Euroley Poultry Production Complex (SSD 6882)

RESPONSE TO SUBMISSIONS

1 September 2015

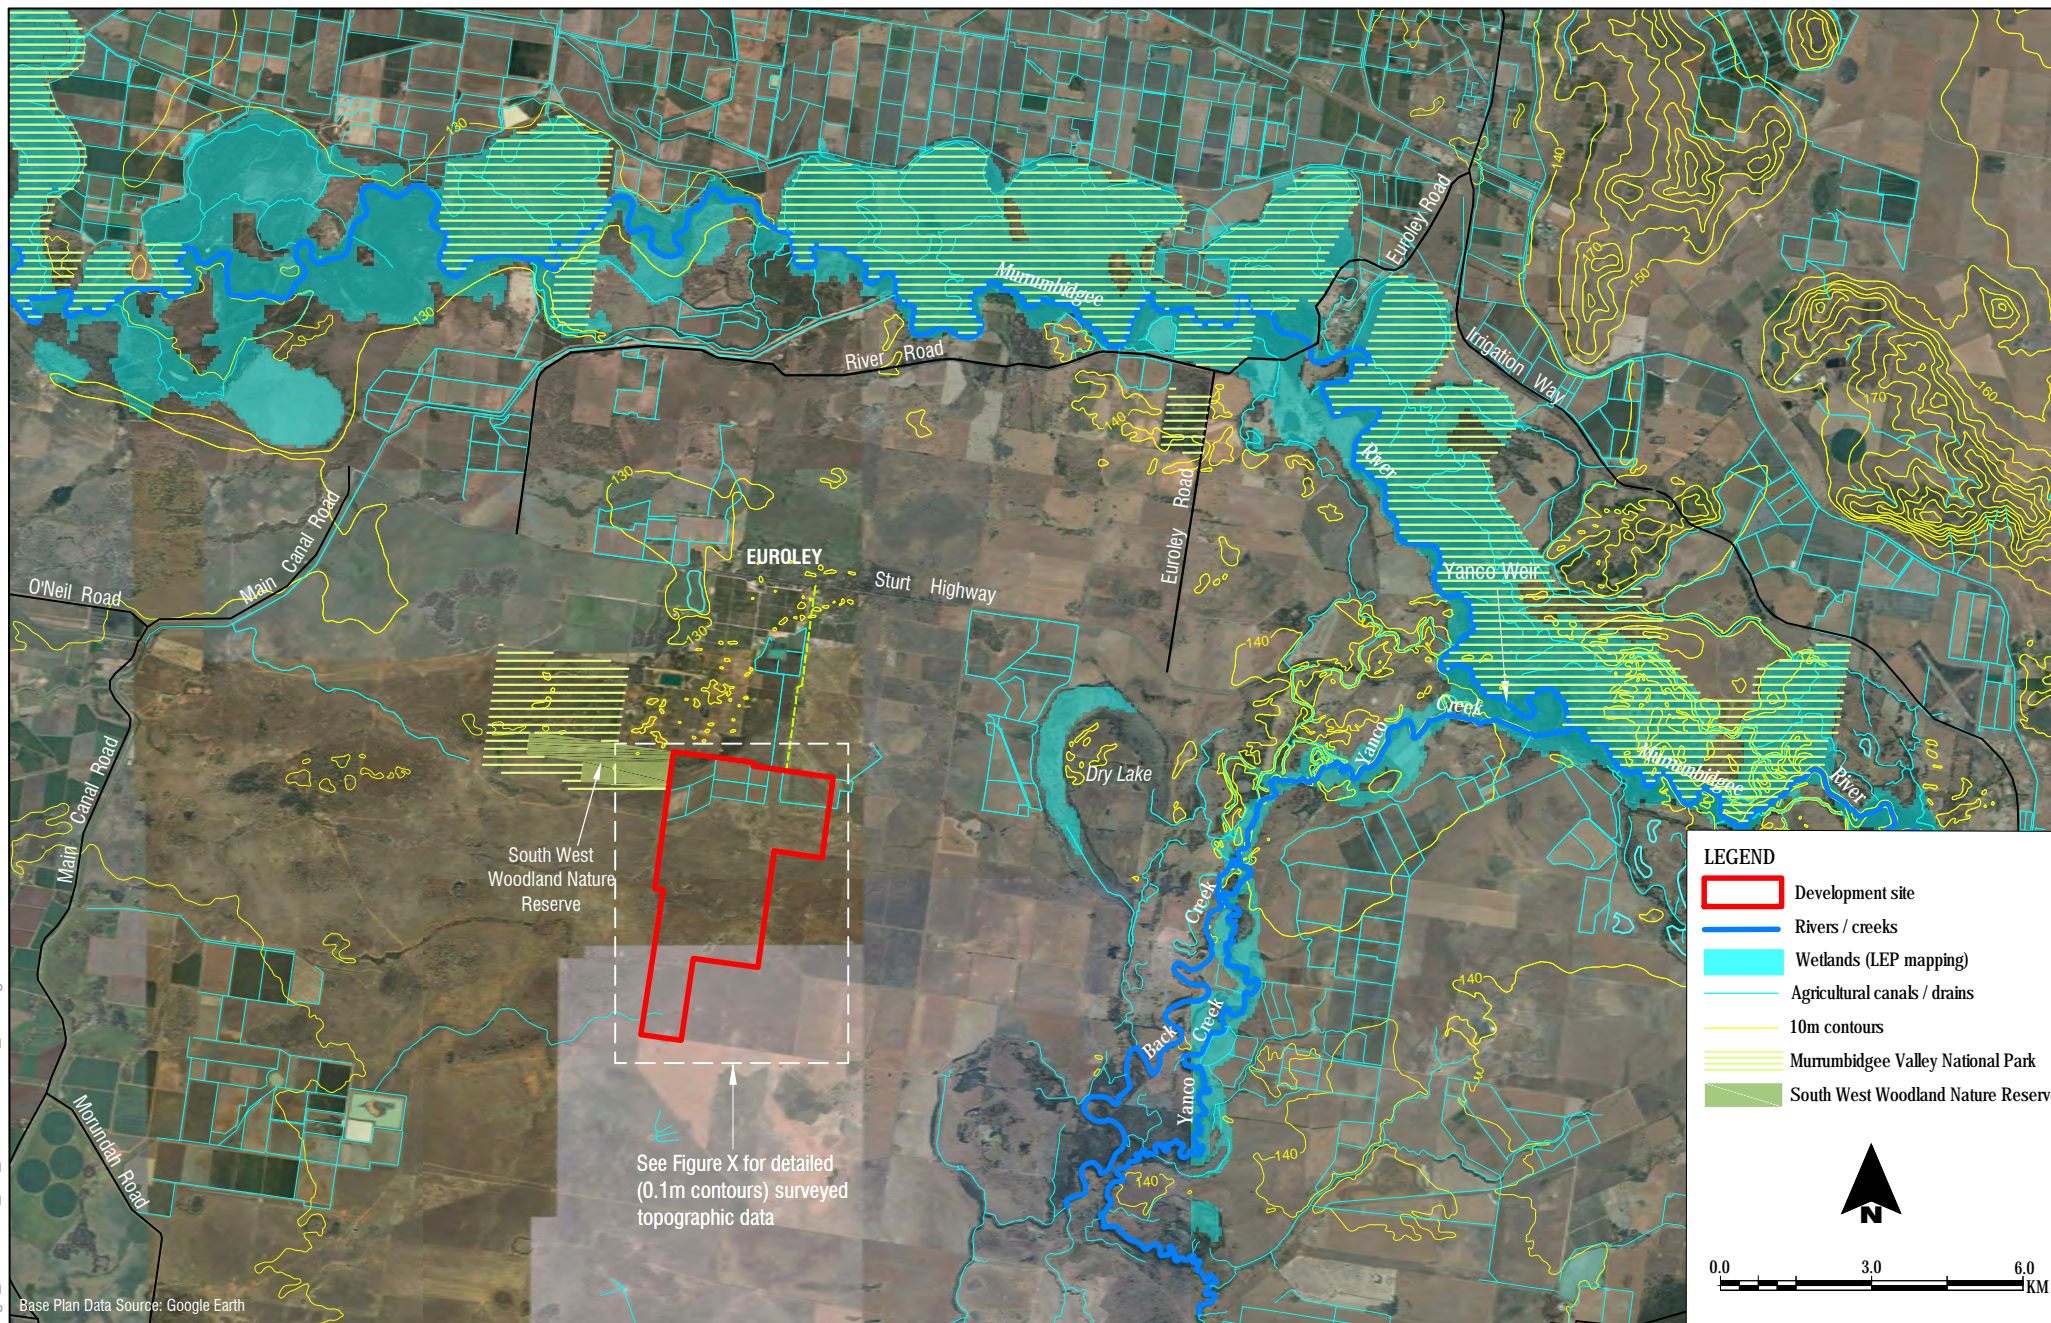
Figure 6.8 should show the route for Option 6 for the off-site transportation of birds.

Please see **Figure 9** (revised Figure 6.8 in the EIS), which has been amended to show the route for Option 6.

Development Site Existing Topography
FIGURE 8

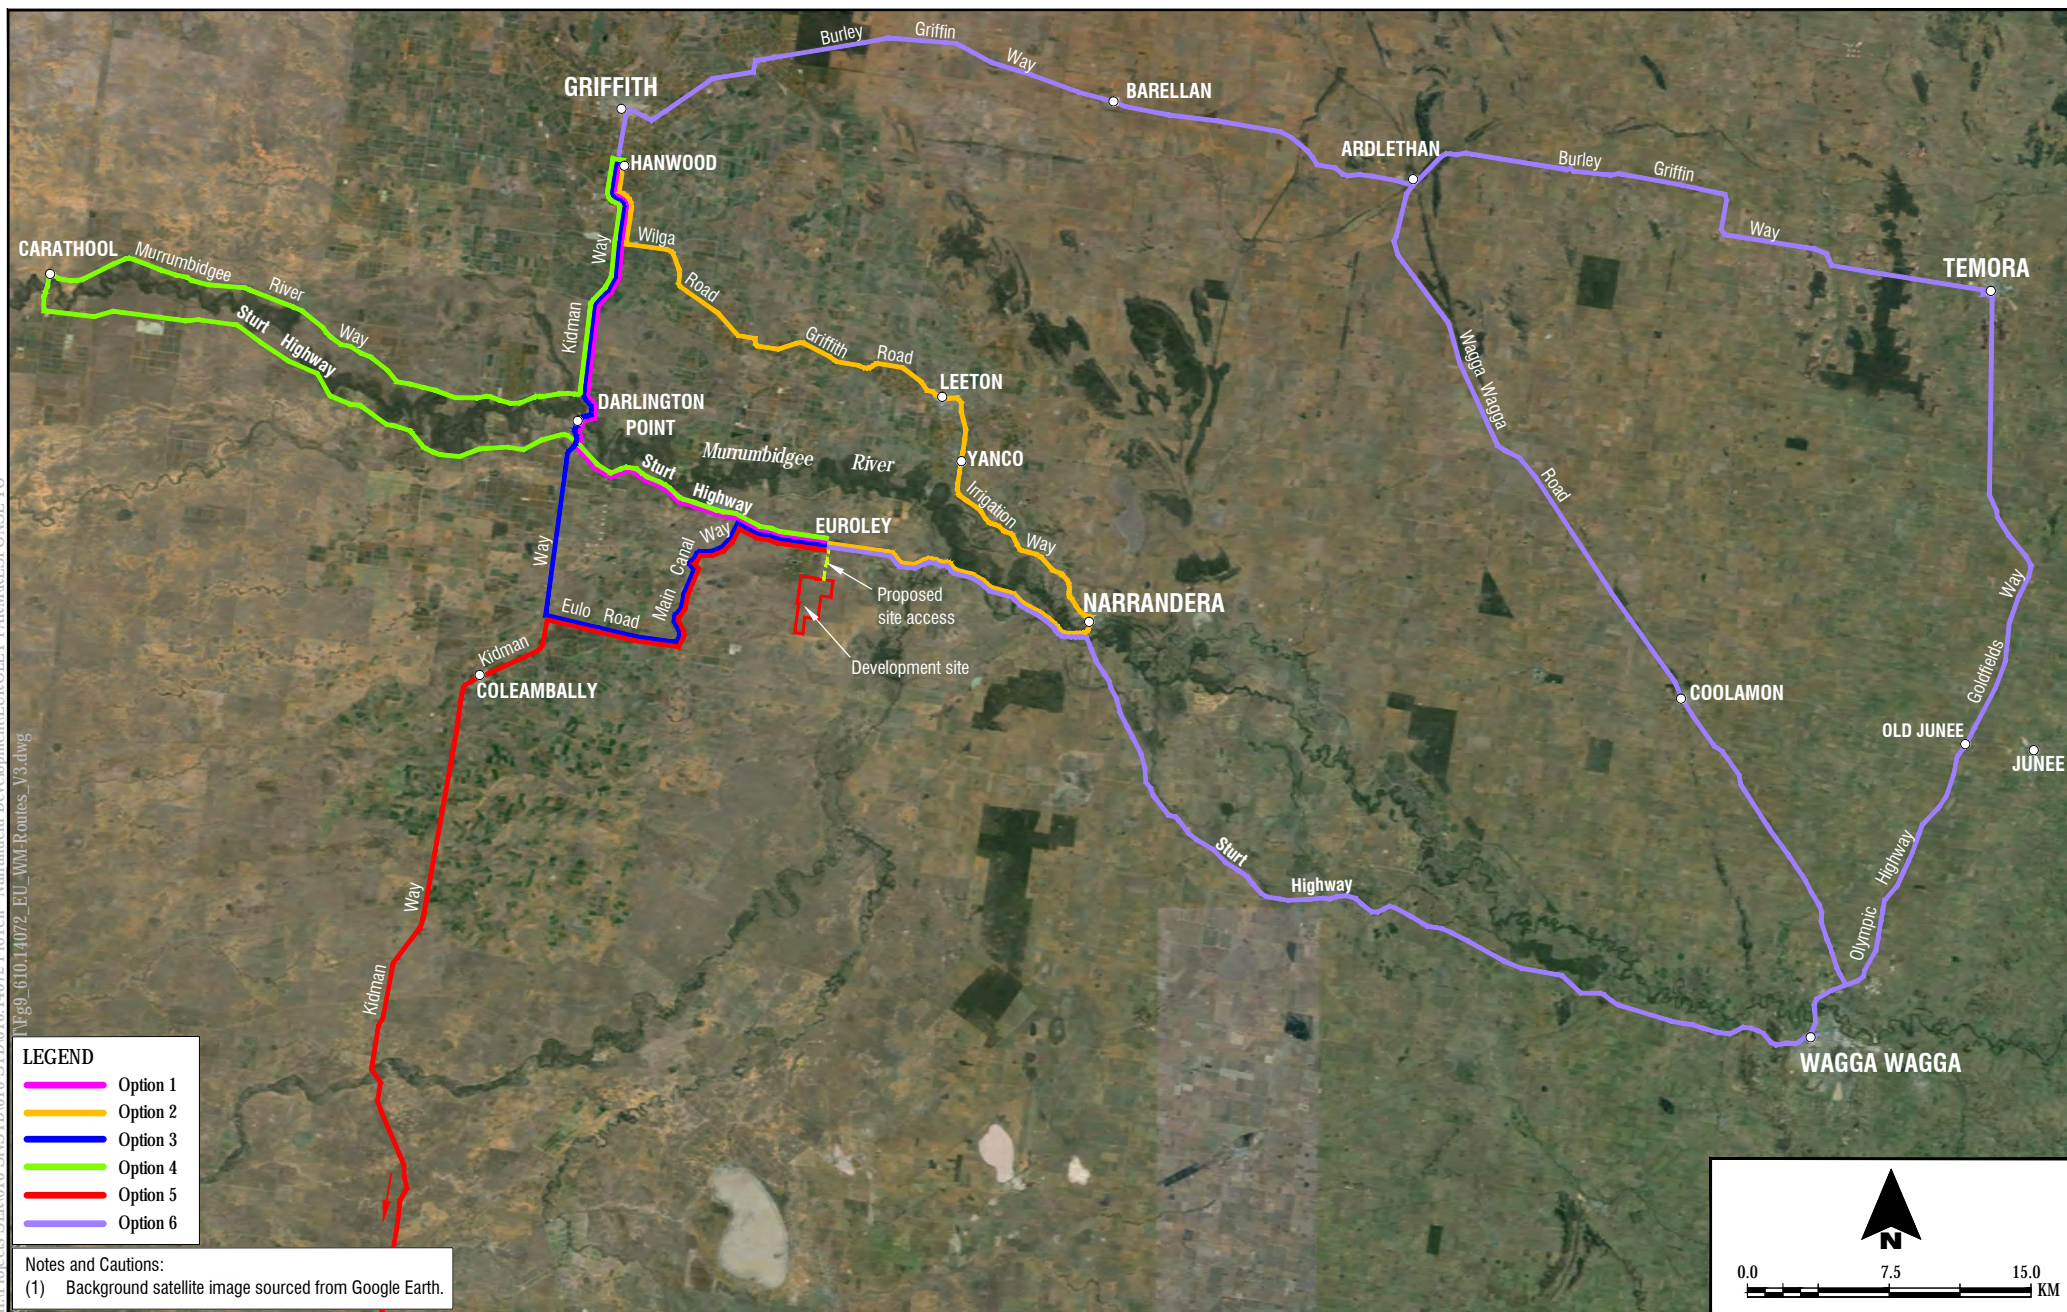
A site constraints plan should be provided that shows all relevant external and internal features of the site (e.g. Dry lake, topographical features, waterways).

A site constraints plan showing relevant external and internal features, including Dry Lake, topographical features and waterways, is provided as **Figure 7**. An additional figure showing the recently surveyed topography (0.1 metre contours) within the development site is provided as **Figure 8**.

Figure 10 - K Factors – ProTen Tamworth (2011)

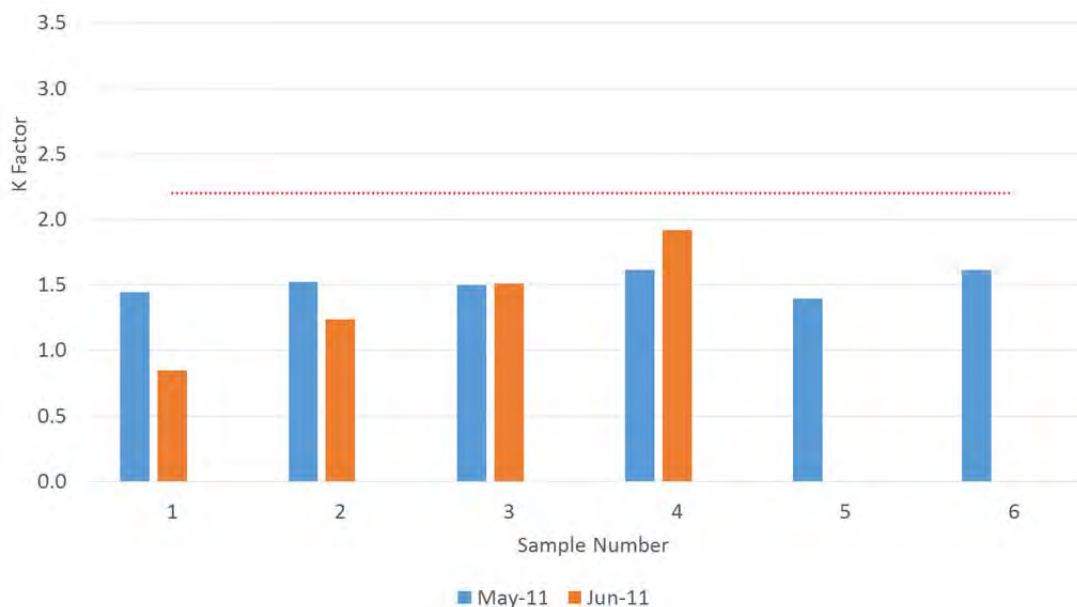
2. Worst case odour emissions have not been estimated.

The EPA requests a sensitivity analysis to determine the impact on the odour assessment results of assuming a K factor of 2.0, 2.5 and 3.0. Further, information on the different shed management practices that correspond to a K factor of 2.0, 2.5 and 3.0 must also be provided. This information will contribute to determining the odour risk to the project (see issue 11).

Pacific Environment reviewed the results of 10 samples collected at a ProTen farm near Tamworth in 2011 by The Odour Unit. The first six samples (in three sheds) were collected in the week leading up to first pickup (days 27 and 28) and the remaining samples were collected at day 41. This data is summarised in **Figure 10**, with the red line representing a K factor of 2.2. The average K factor for this period was 1.5.

Figure 13 - Modelled PM₁₀ Emissions

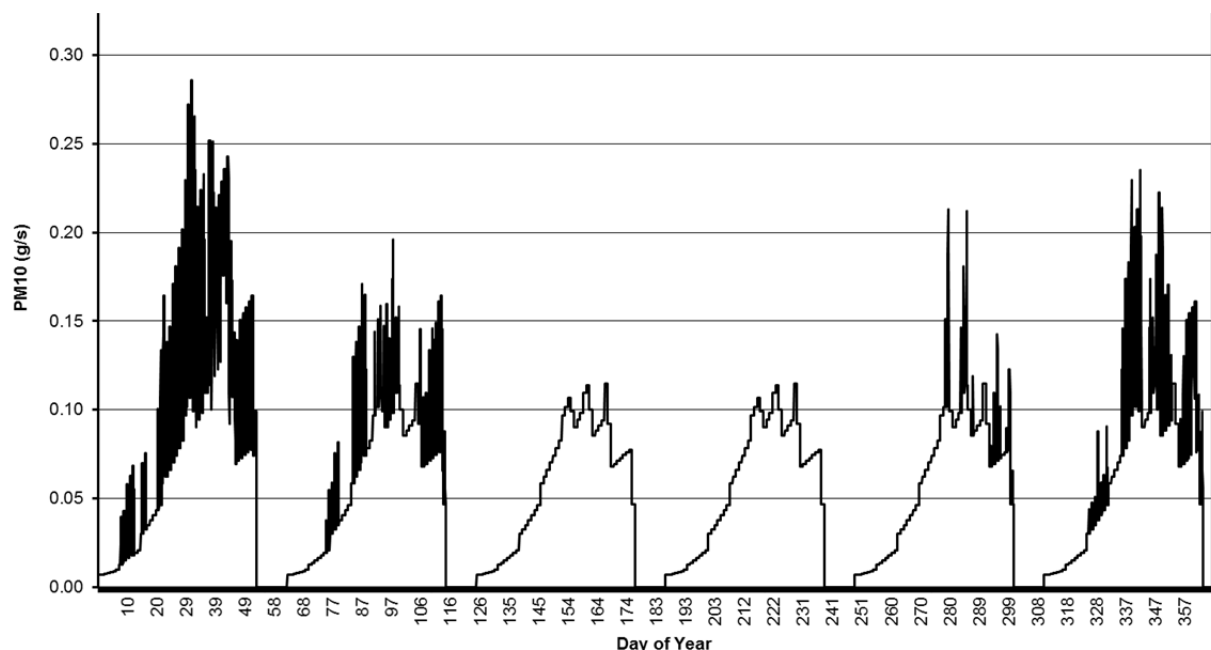
3. *Modelled shed particulate emission rates have not been provided.*

Pacific Environment's (2015a) modelled PM₁₀ emissions rates on a per shed basis are shown in **Figure 13**.

Figure 20 - Groundwater Analytical Model Predictions

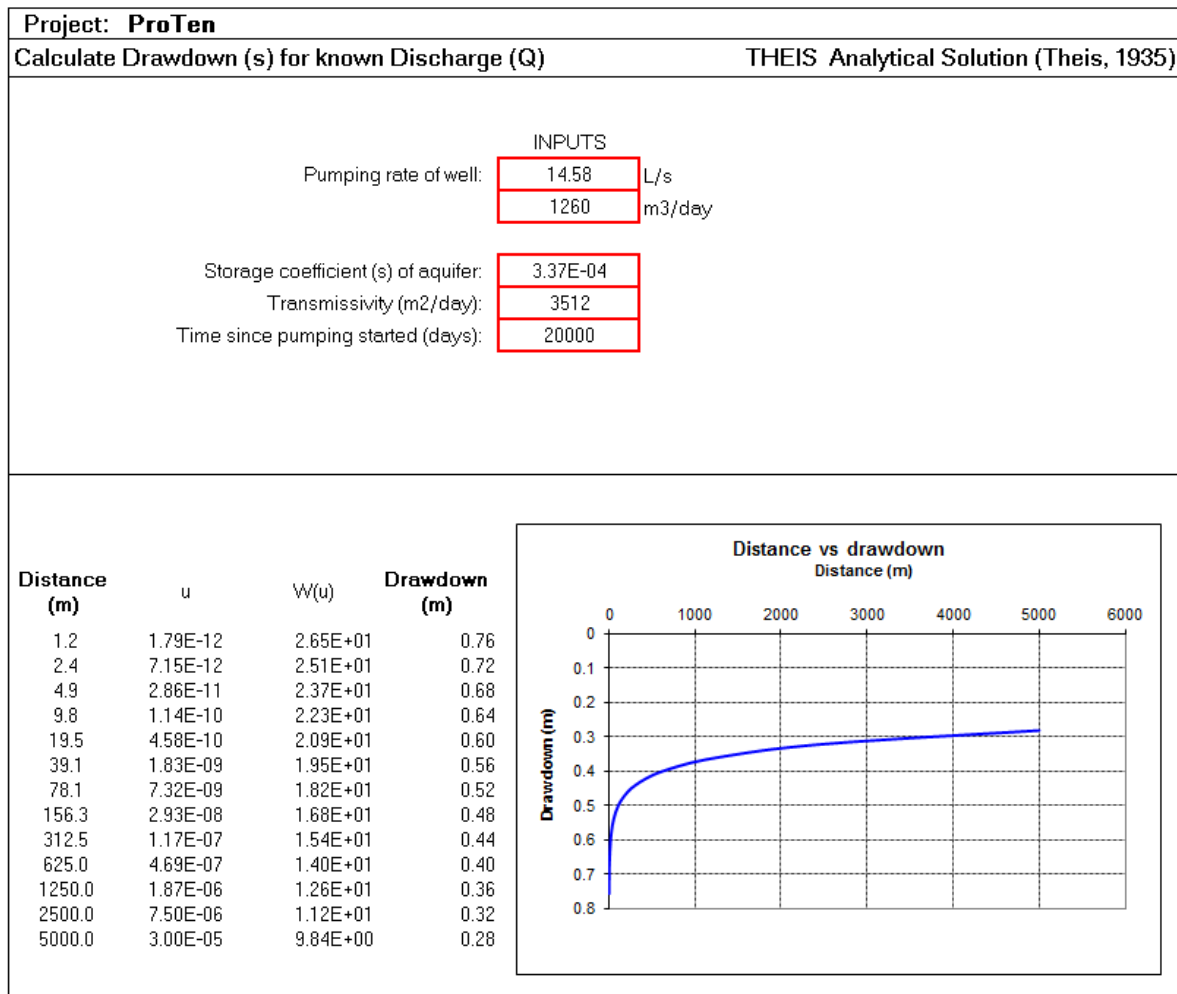
5. The assessment of potential impacts of 460 ML extraction on nearby bores is considered inadequate and it is recommended that the analytical model be re-run to assess the impact of extraction using modified aquifer parameters and a longer pumping period (i.e. 2,000 days).

The results of the analytical model, which are presented in **Figure 20** below, show a predicted maximum long-term drawdown of 0.8 metres in the immediate vicinity of the pumping bore, with the 0.5 metre drawdown radius extending only around 110 metres from the pumping bore.
